# Amendment Notice 3

**Licence Number** L4496/1988/11

**Licence Holder** Big Bell Gold Operations Pty Ltd

**Premises** Blue Bird Gold Mine  
Mining Tenements; G51/9, L20/75, L51/18, L51/78, M20/12, M20/45, M20/68, M20/70, M20/71, M20/73, M20/77,, M20/107, M20/214, M20/219, M20/249, M20/421, M51/6, M51/12, M51/31, M51/33, M51/35, M51/39, M51/62, M51/75, M51/92, M51/96, M51/132, M51/190, M51/199, M51/200, M51/203, M51/209; M51/211, M51/233, M51/236, M51/237, M51/254, M51/321, M51/393, M51/437, M51/438, M51/439, M51/440, M51/455 M51/459, M51/462, M51/463, M51/483, M51/485, M51/486, M51/491, M51/492, M51/493, M51/494, M51/495, M51/523, M51/539, M51/569, M51/572, M51/581, M51/564, M51/666, M51/671, M51/672, M51/757, M51/762, M51/781; M51/784, M51/788, M51/793, M51/794, M51/795, M51/800, M51/801, M51/820, M51/824, M51/834; E51/1484  
MEEKATHARRA WA 6642

Paddy's Flat landfill

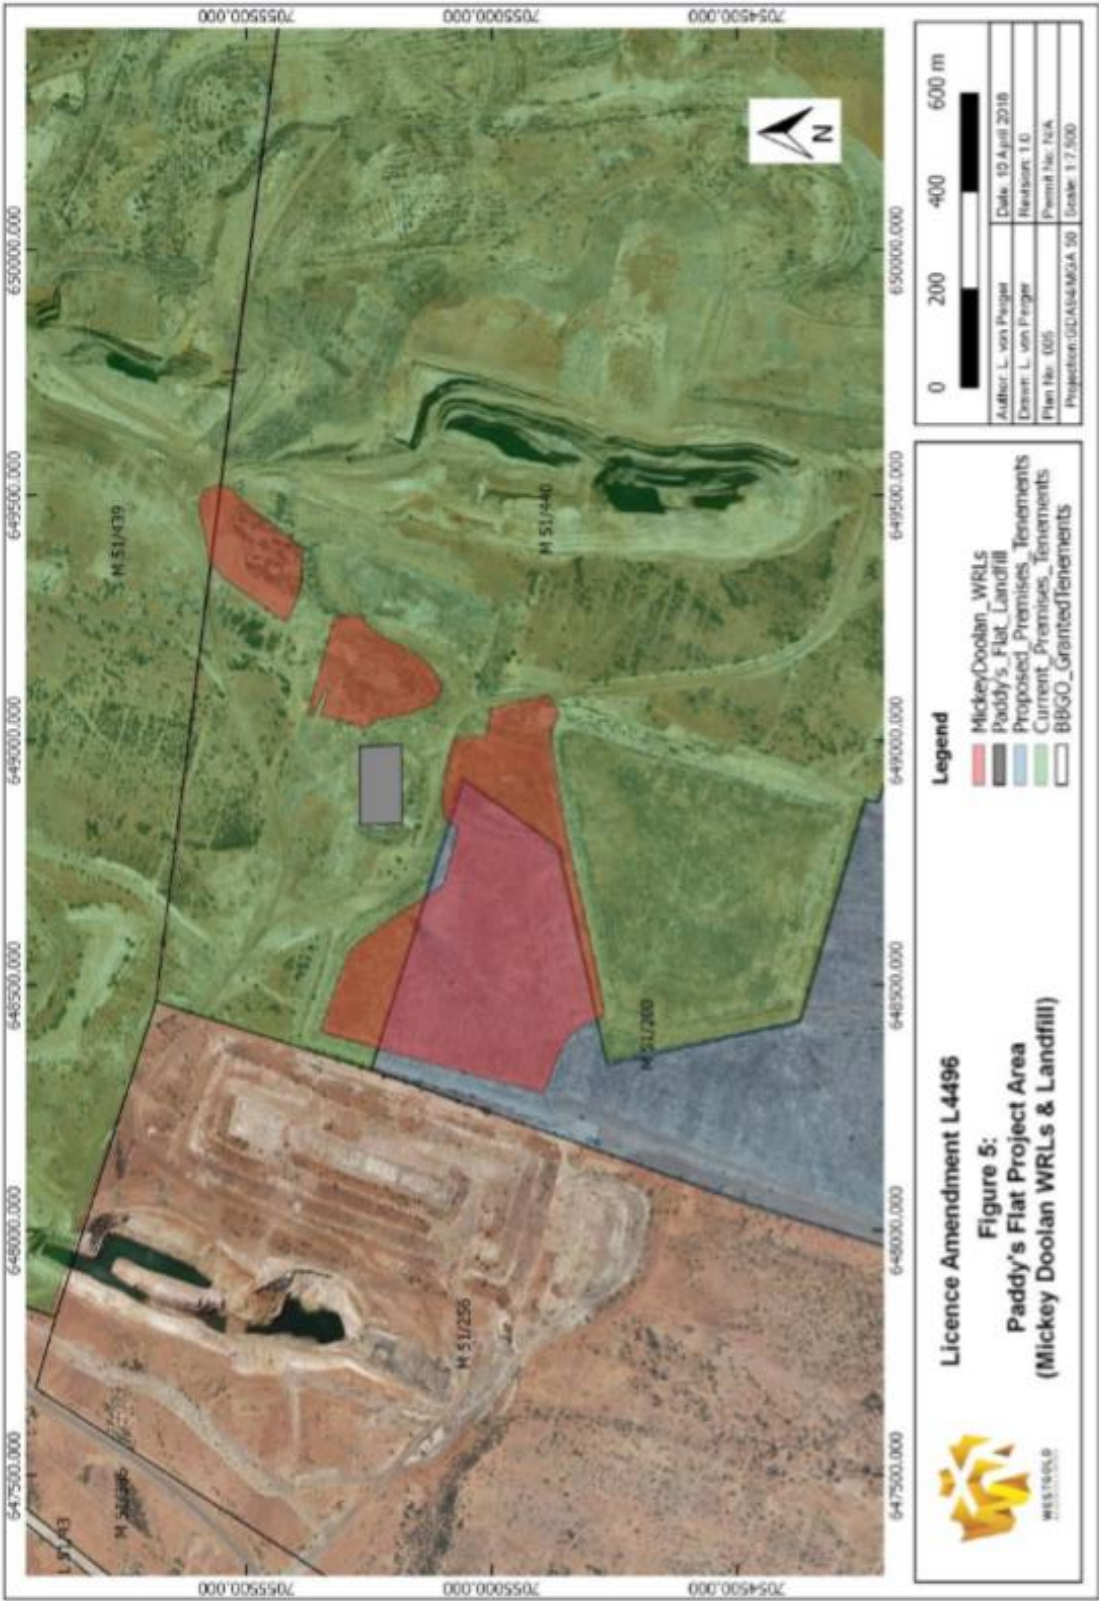
7. The Licence is amended by the insertion of two maps (shown below) in Schedule 1 under the heading Maps of landfill locations;

Schedule 1 has been updated with two additional maps showing the location of the two new landfills.

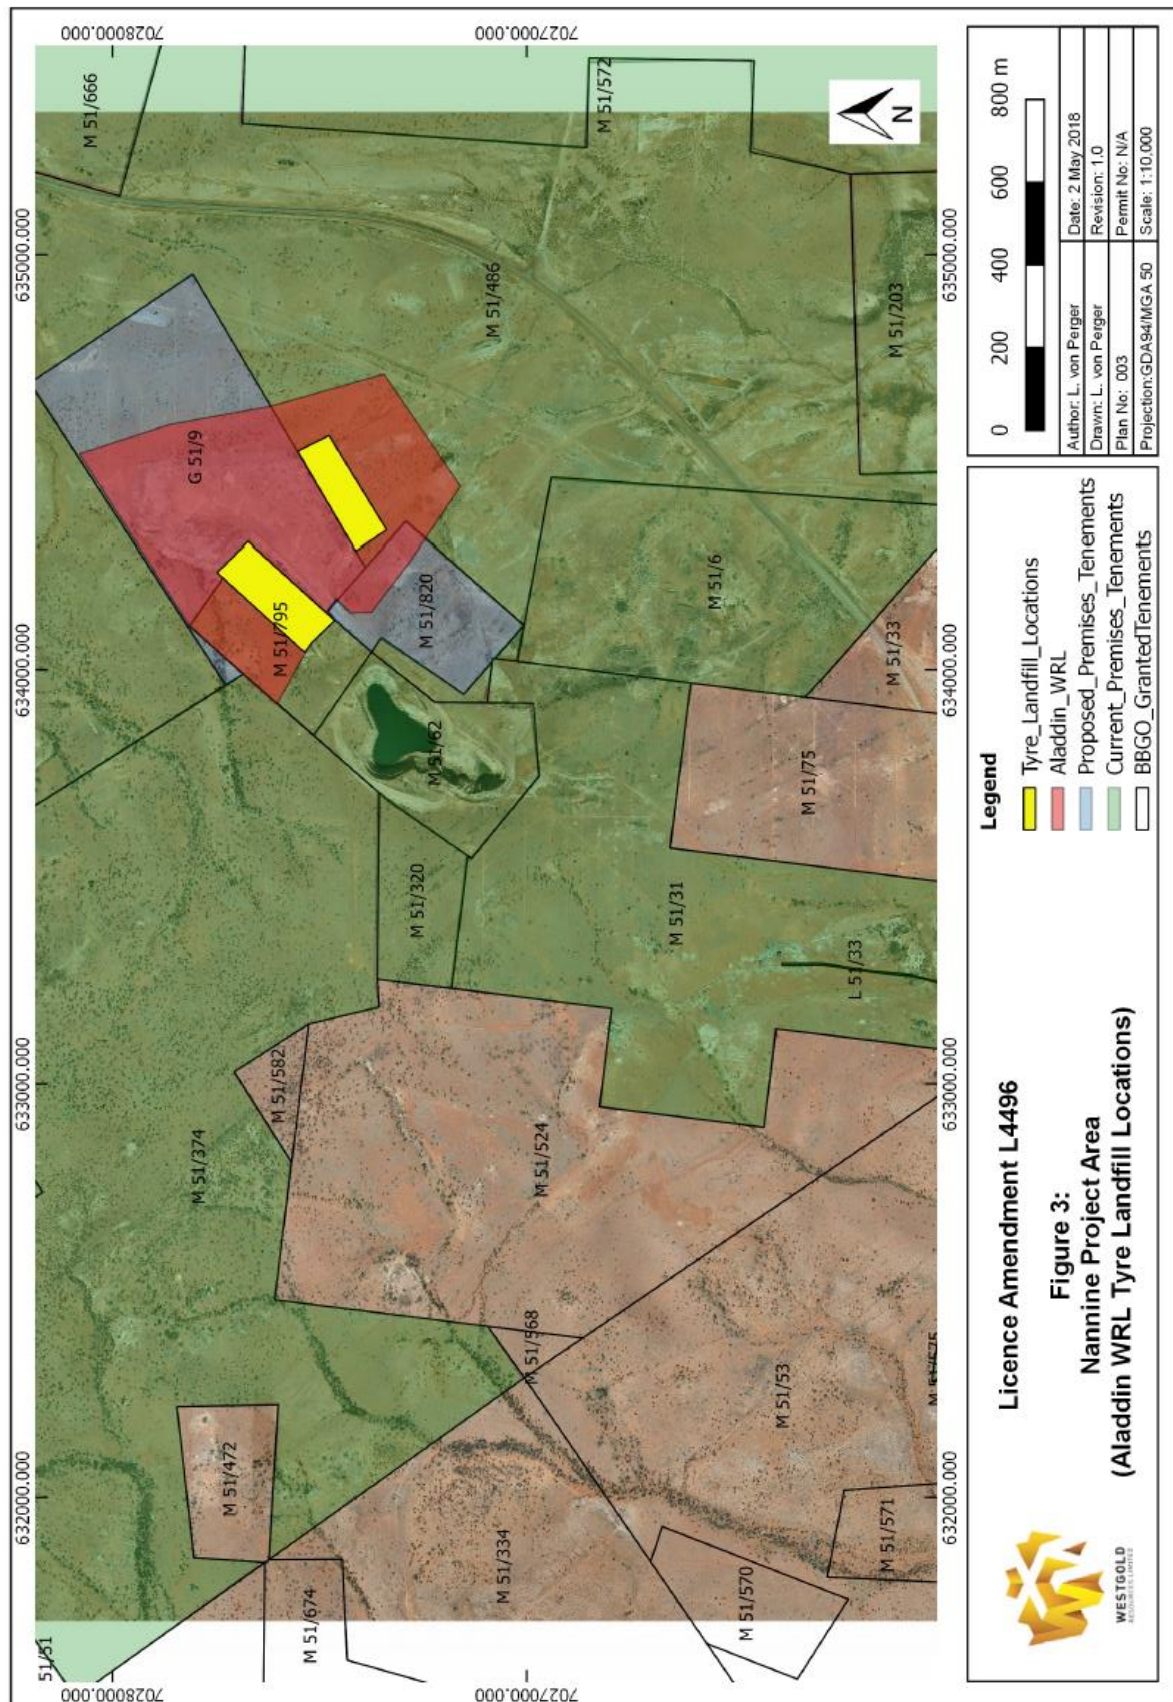
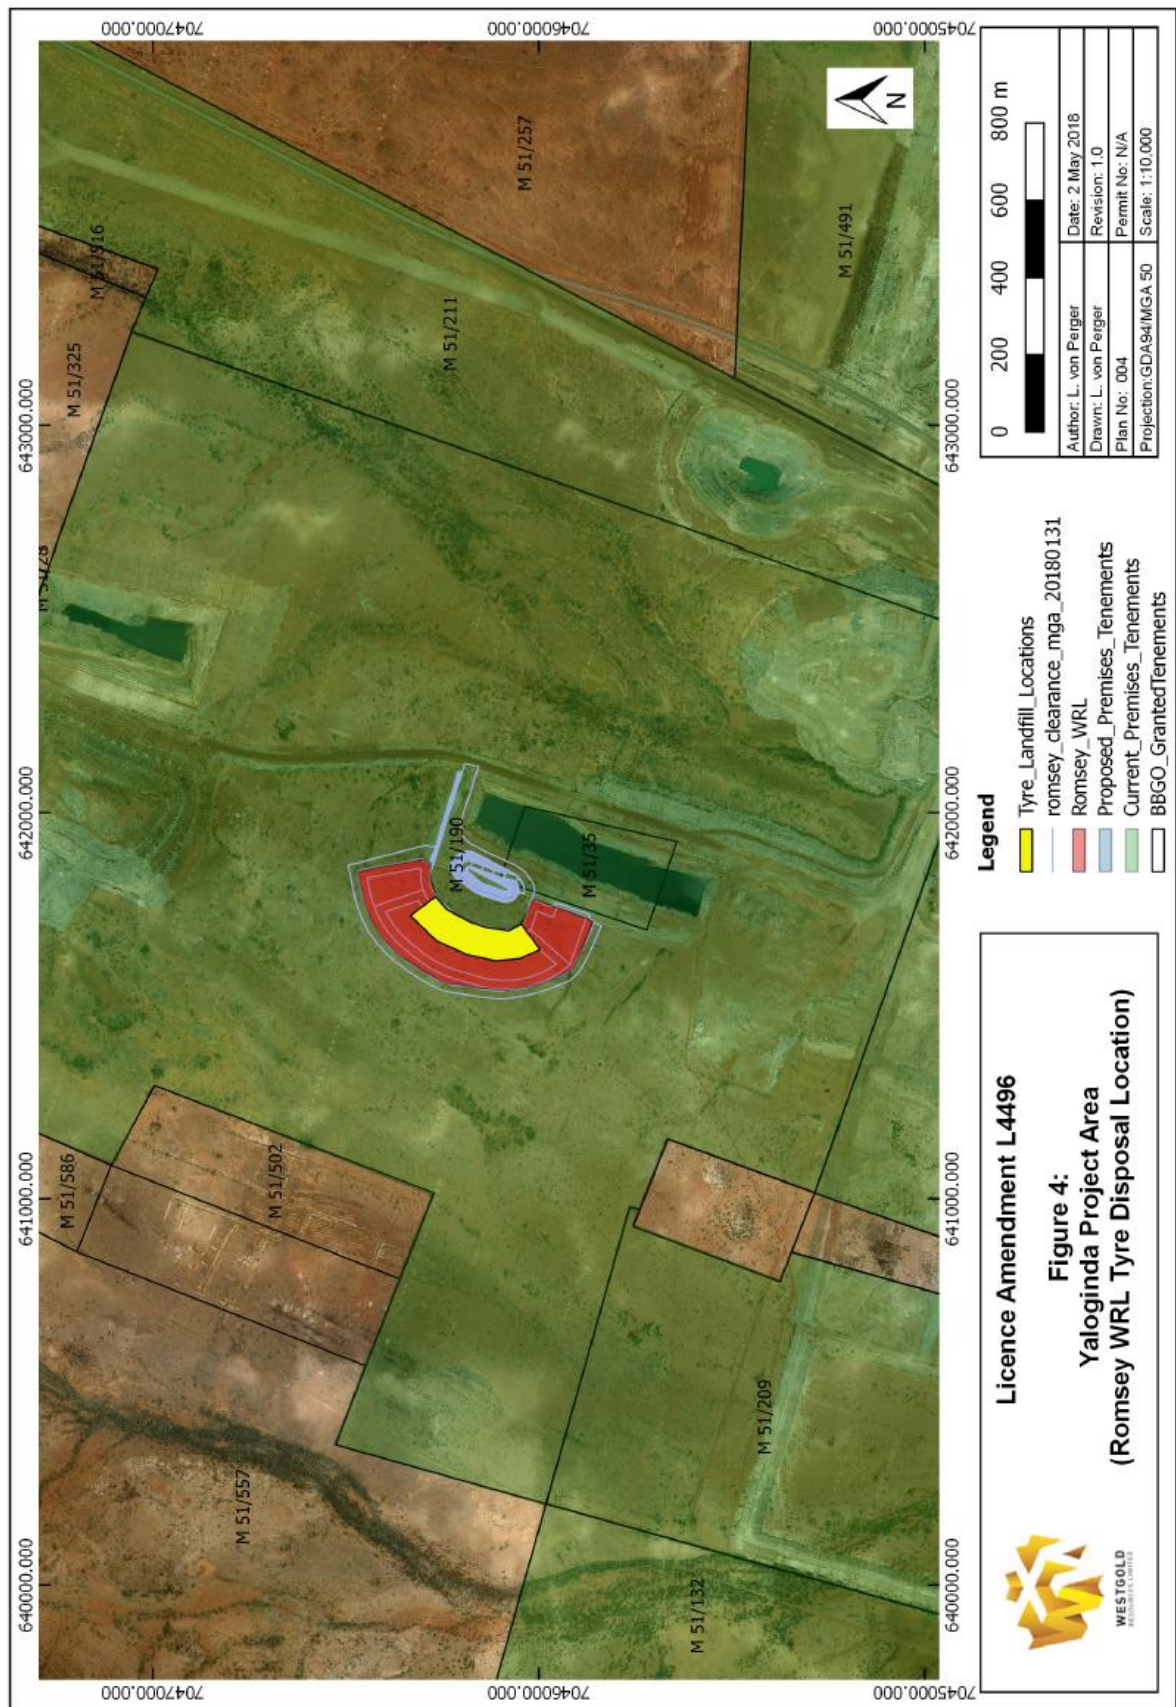
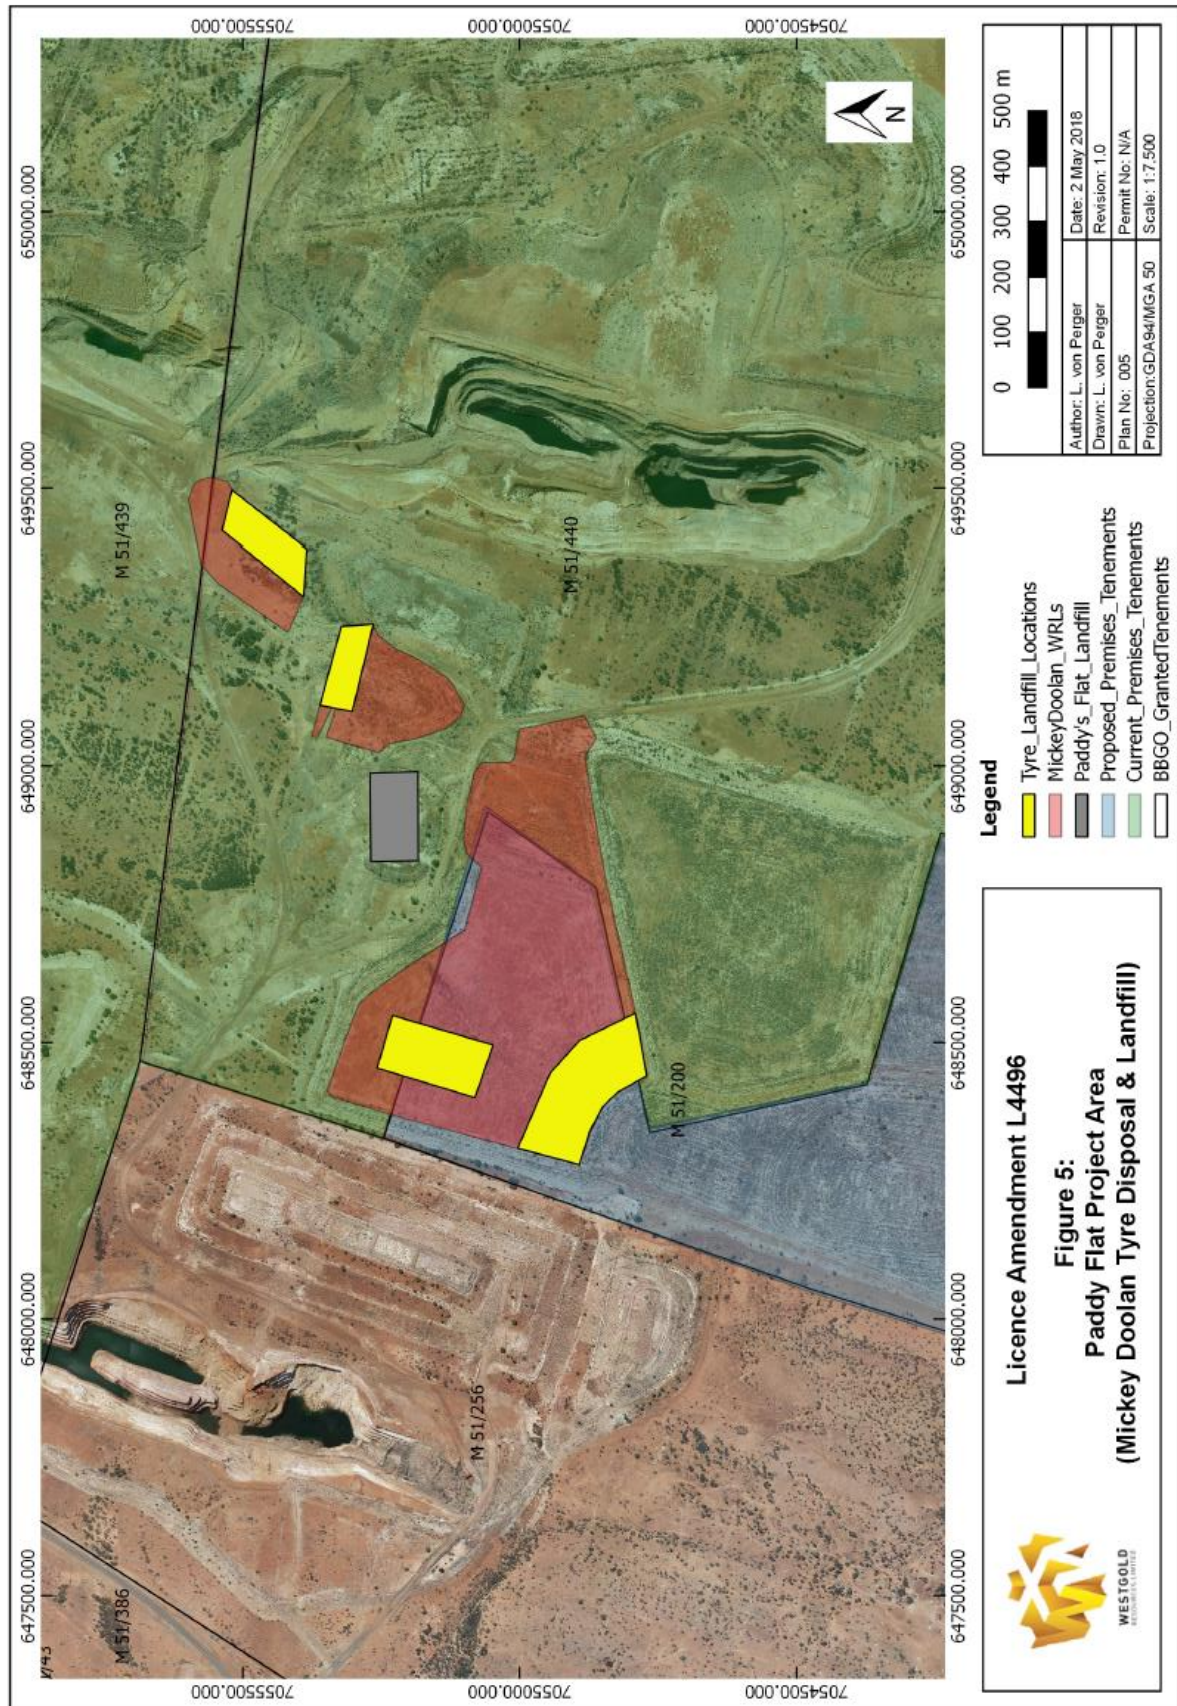
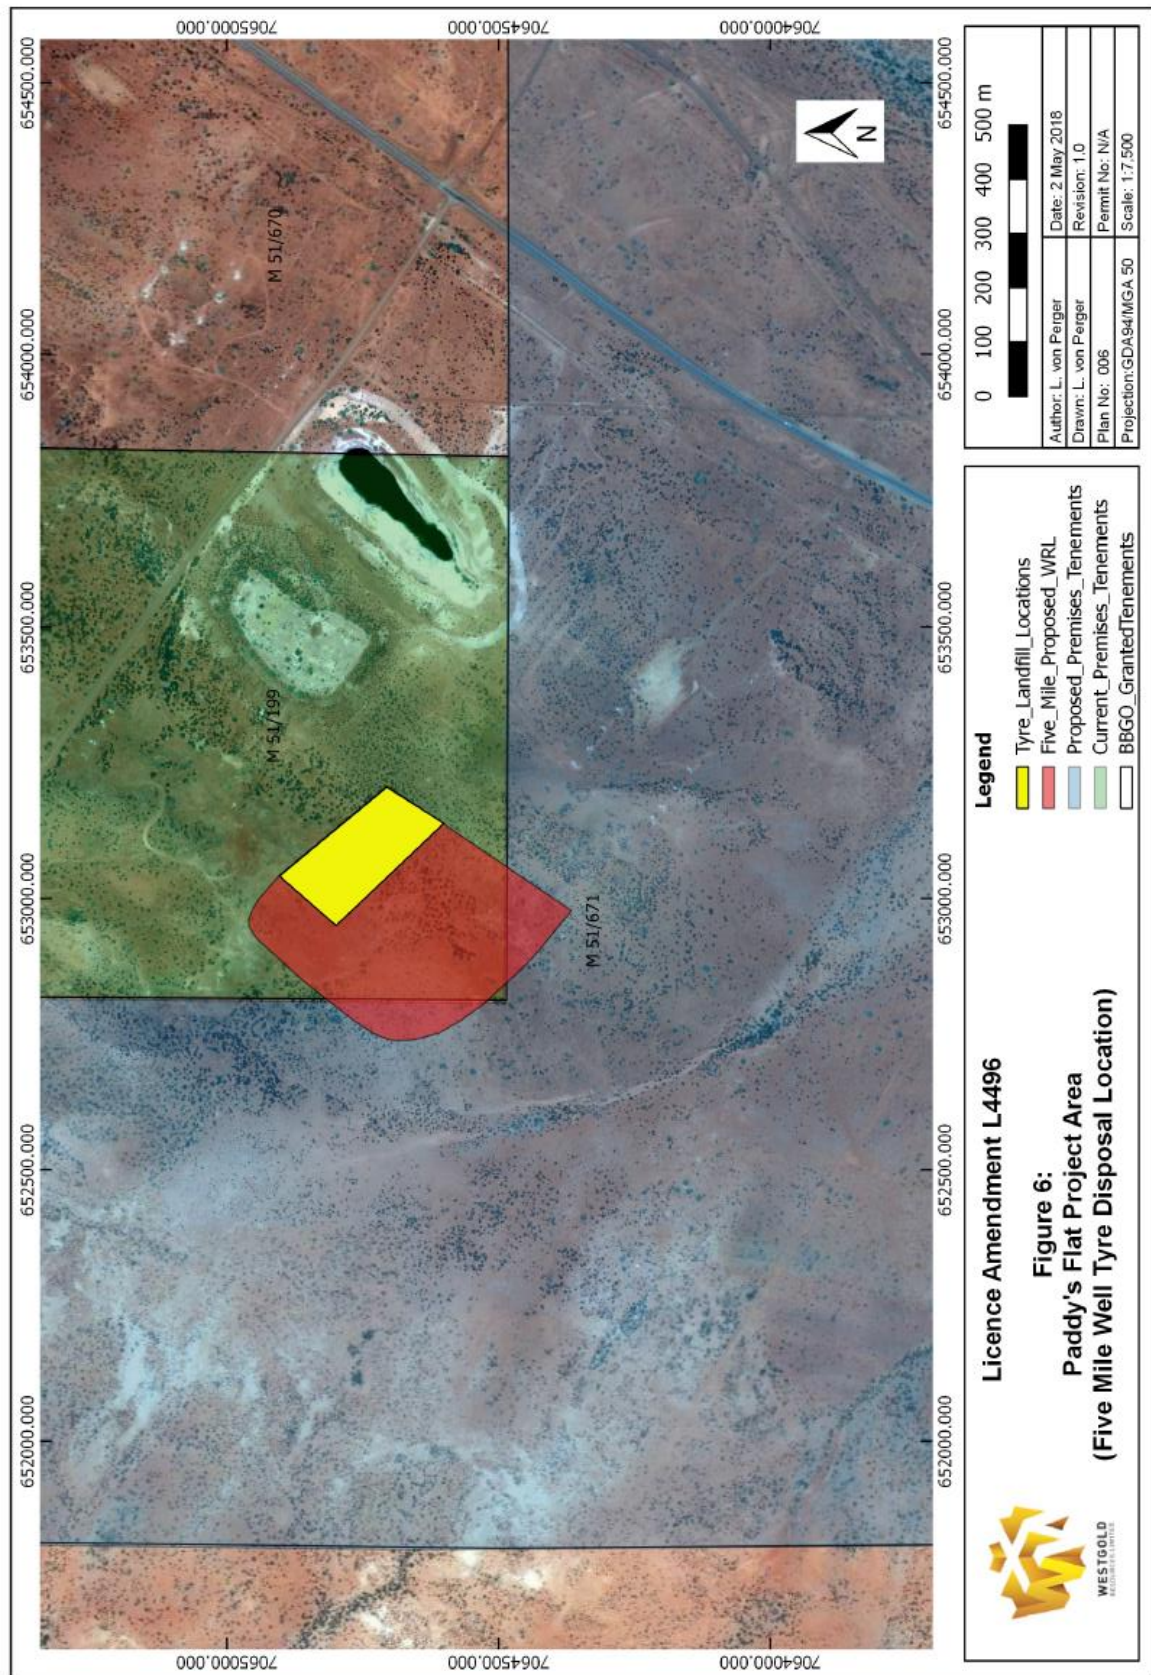
8. The Licence is amended by removing the map in Schedule 1 Map of tyre disposal locations and insertion of the maps below;

Schedule 1 tyre burial location map has been replaced with four maps outlining the location of the new tyre burial locations.
